# Feedback form: New Zealand's draft National Infrastructure Plan

Project IPP0003141

Te Marua Water Treatment Plant Scheme Expansion Stage 1 (Pakuratahi Lakes)

Location of Wellington Fault relative to the existing facilities at Te Marua and proposed at Pakuratahi

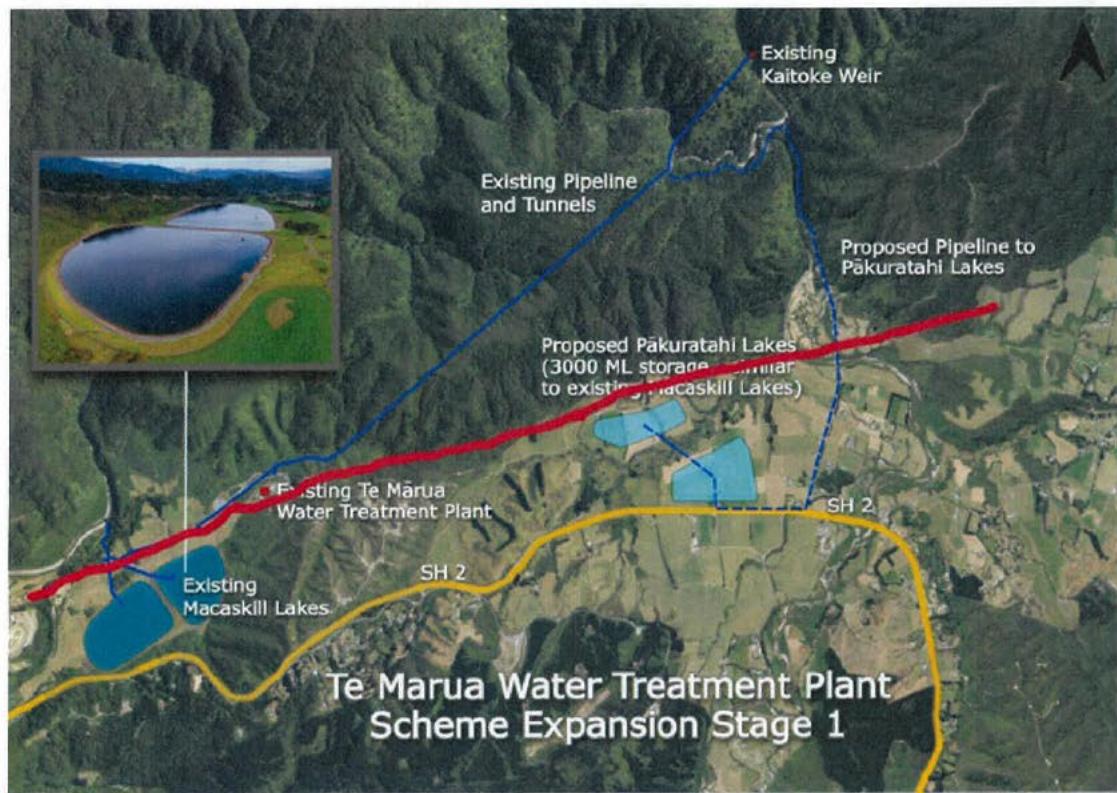
On the Wellington Water image below which I think formed part of the application, I have marked the approximate location of the Wellington fault. Note that it passes close to the Macaskill lakes, crossing the large diameter pipelines between the lakes and treatment plant, and also close to the proposed Pakuratahi lakes.

The second image below GW plan no A1-10185-03-BS shows in more detail the location of the fault and the existing facilities at Te Marua.

What a rupture of the fault will do to the integrity of the lakes and treatment plant is indeterminable, but certainly the large pipes (which are up to 1000mm diameter) will be ruptured over significant lengths. Reconnecting these pipes will be no easy task.

This image GW plan A1-10185-03-BS shows the Wellington fault location in relation to the Te Marua facilities

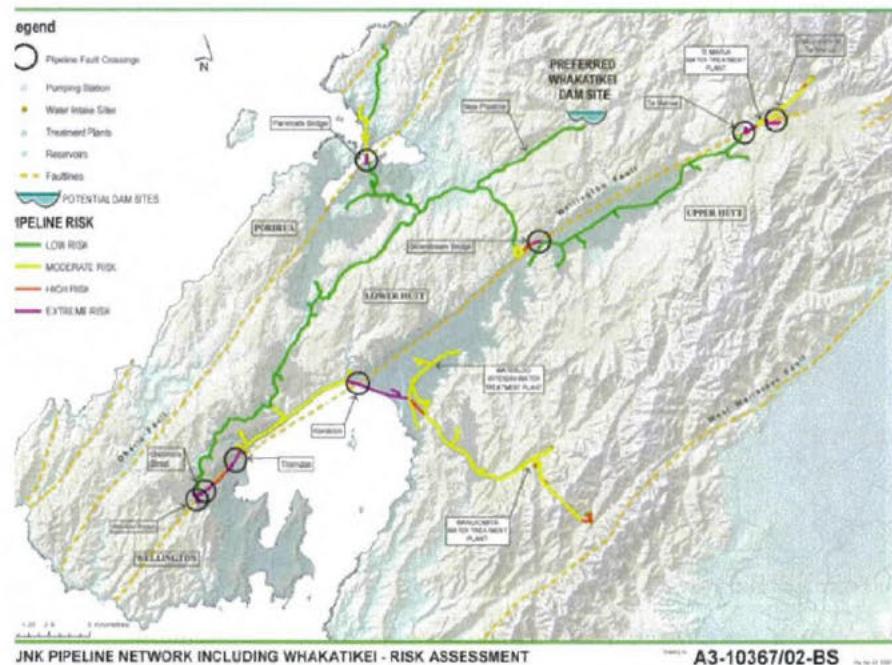
The GW plan A3-10367/02BS below shows an assessment of the relative vulnerability of the bulk water supply system. Note that the possible Whakatikei intake and connecting pipeline to Judgeford are also shown for comparison.

- Water treatment plant pipelines to process and wash water tanks on the hill crossing the fault.
- Macaskill lakes very close to the fault. With the lakes having a large extent, uneven settlement following fault rupture could cause overtopping, as well as failure of the earth embankments.

- Pipes connecting the lakes to the pumping station being 4 at 900mm diameter and also large drainage pipes cross the fault.
- Crossing of fault by the main delivery pipeline south of the lakes. Some mitigation installed at this point to enable a limited connection.

GW plan A1-10185-03BS This image shows the approximate position of the Wellington Fault in relation to the Te Marua facilities, including the, lakes, pumping station and pipelines.
